Construction Division
Additions & Alteration Charges Approval Form

GULMOHAR RESIDENCY

Details of Additions & Alterations

Flat No	106	Block no.	' D ' ✓
Flat Area	1660 sft	Type	Deluxe / Luxury
Buyer Name	Ravi Prasad R.V.S.K		
Phone No.		Email

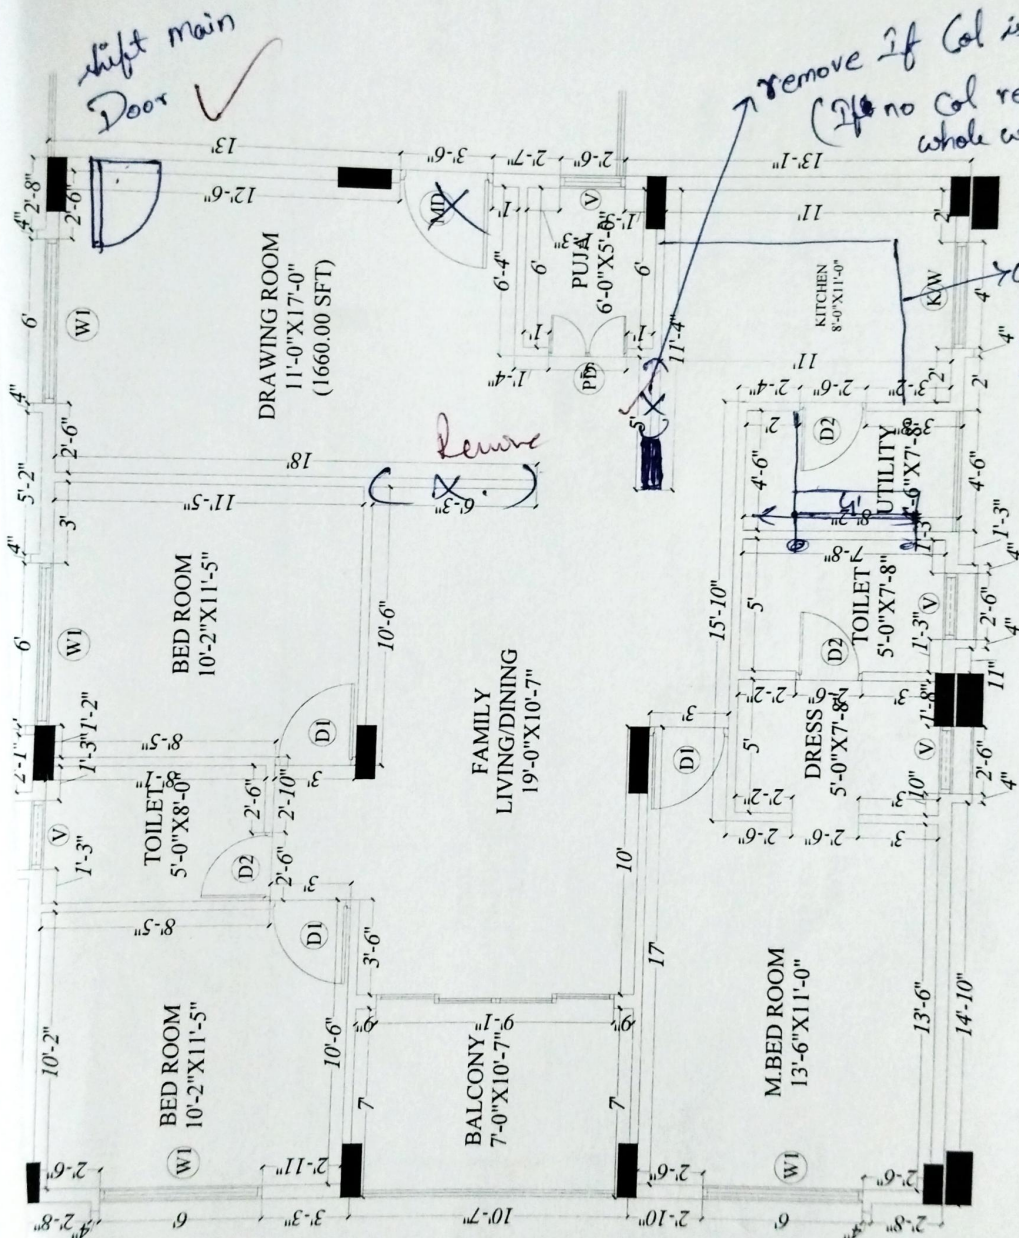
- ② Extra wash basin in Dining room as
shown in plan

- ① Leave wall ^{opening} for window. A-C in children B.R.
- ② False Ceiling in Hall, Dining & Passage areas
+ give estimate for B/R false roof

Pooja
~~kitchen~~ room granite racks as per.
 0-105 flat

PLUMBING PLAN-1660 Sft (B1-TYPE)

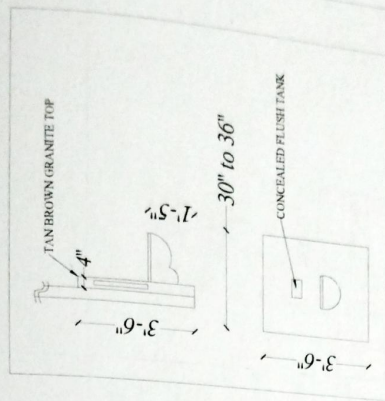
Two links
